**JORDAN VALLEY WATER CONSERVANCY DISTRICT
WELL PUMP STATION CONSTRUCTION
700 EAST (7618 S 700 E, SANDY CITY)
1000 EAST (7750 S 1000 E, MIDVALE CITY)
DOCUMENT 00 91 13.1
ADDENDUM NO. 1**

- A. The Construction Contract is known as: **JORDAN VALLEY WATER CONSERVANCY DISTRICT – WELL PUMP STATION CONSTRUCTION, 700 EAST (7618 S 700 E, SANDY CITY), 1000 EAST (7750 S 1000 E, MIDVALE CITY**
- B. Date of this Addendum: December 3, 2024.

| TITLE | | PowerPro 3075 w/Auto Control Valve | |

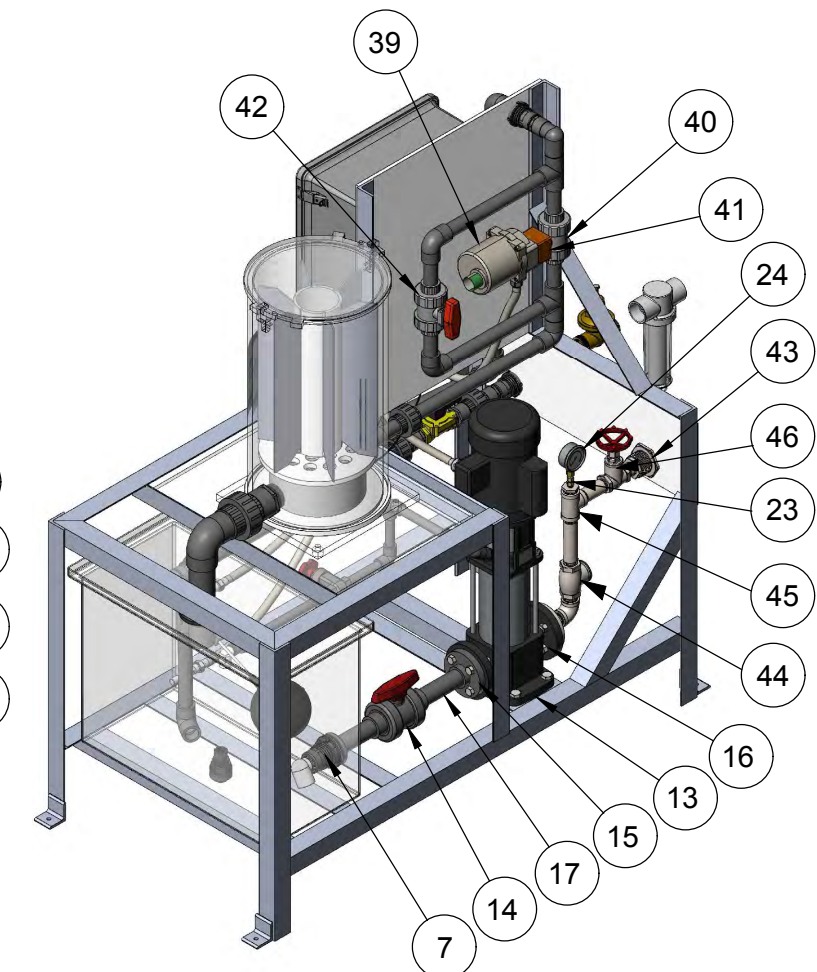
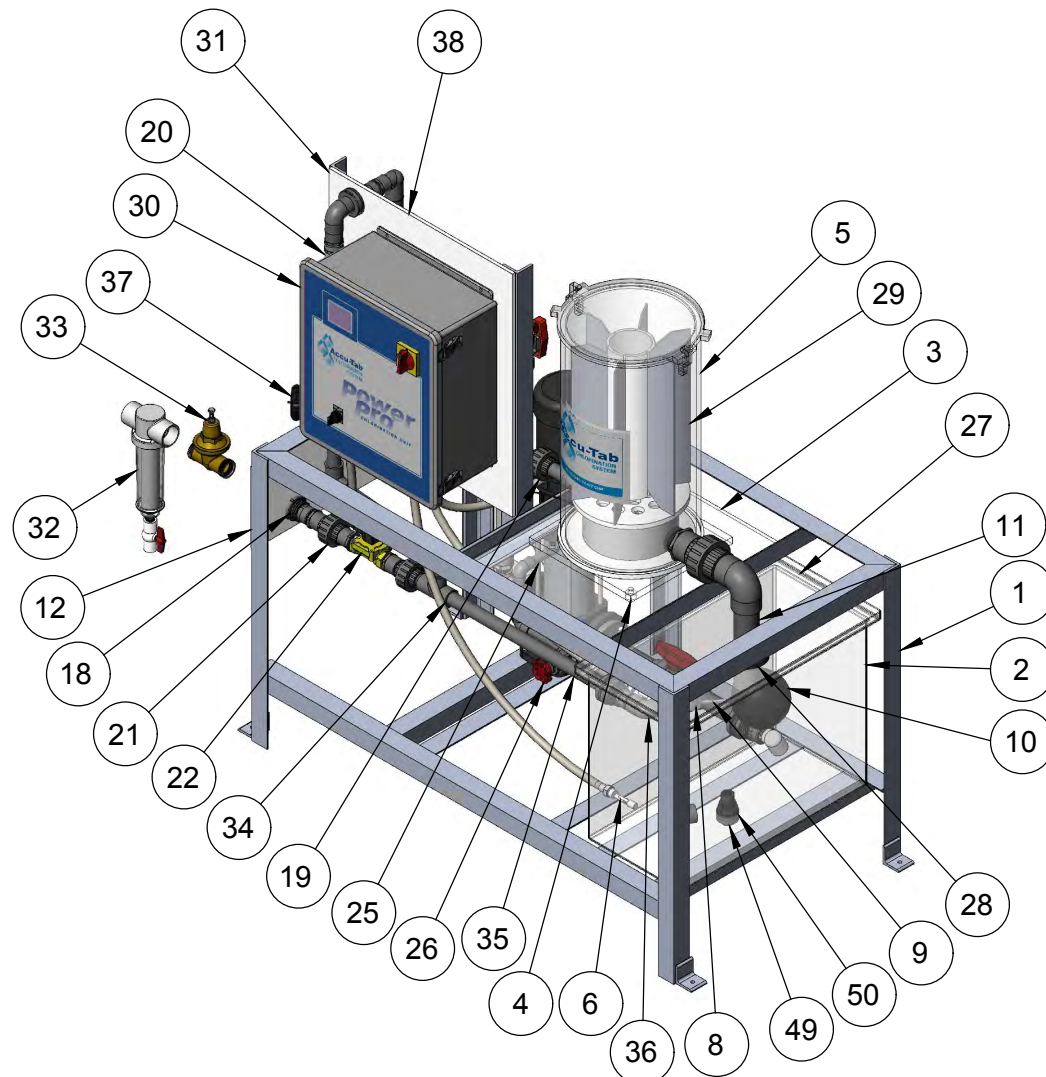
- Q. *Will JVVCD provide a cut sheet for the Tablet Chlorinator that Owner is to supply, and the Contractor is to install at the 1000 East Well Pump House?*

- A. No.
- Q. *Please provide the scope of supply for Tablet Chlorinator that the District will be providing.*
- A. See the schematic attached. That includes what JVVCD will be supplying. The Contractor is to provide all other piping, valves, etc. to and from the Tablet Chlorinator and is responsible for testing and startup.

- A. Attached is a schematic of the Tablet Chlorinator the Owner will be supplying.
- Q. *The surge tank for 1000 East is 6'6" long. If we use the same size surge vault as 700 East, the tank will extend 4' into the vault from the outside edge of wall. That only leaves 2.5' of tank outside of the vault. There won't be much room for the tank support (B/ST-4). Will we need the additional tank support, or do we increase the vault wall thickness to provide support?*

Trees to be removed along south and west side of property at 1000 East Site

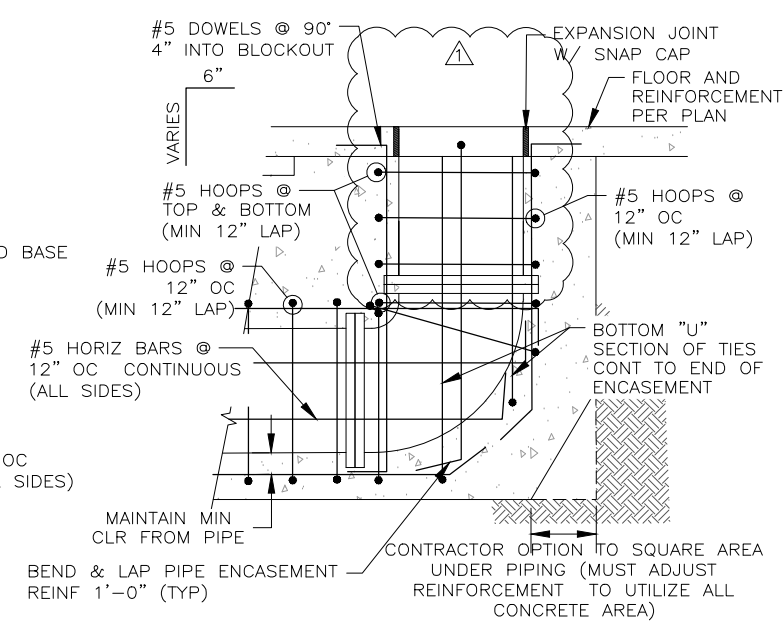
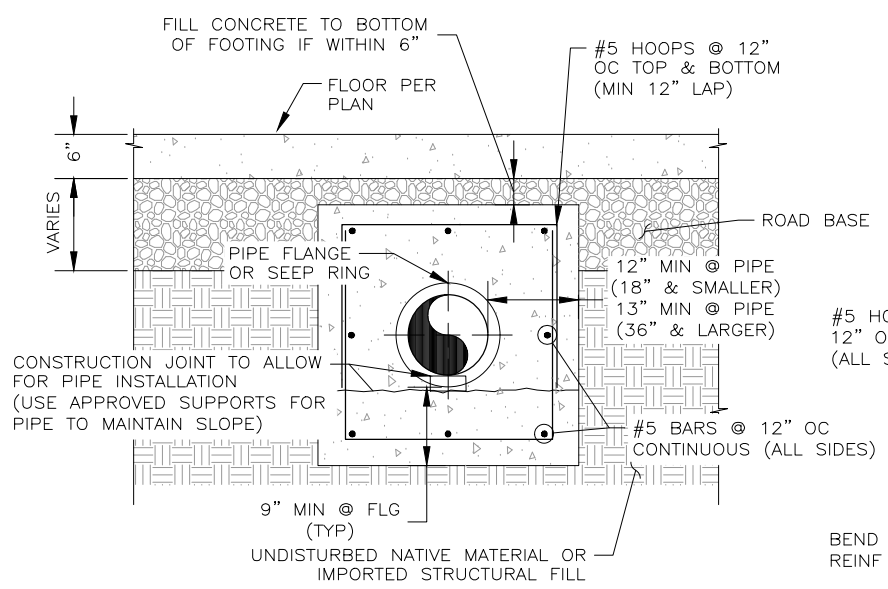
1. Contractor shall remove existing trees along the south portion of the 1000 east property and remove 4' diameter stump on the north side of northern driveway into the site. A bid item has been added to the bid schedule for this work. See attached photos that show trees to be removed along the south portion of the property.

| Item | Location | Description of Change | |
|-----------------------------------|---------------------|--|--|
| 15 | Sheet C-6 | Add the following Note 6: "Contractor shall remove existing trees along south portion of the property and remove 4' diameter stump on the north side of northern driveway into the site." | |
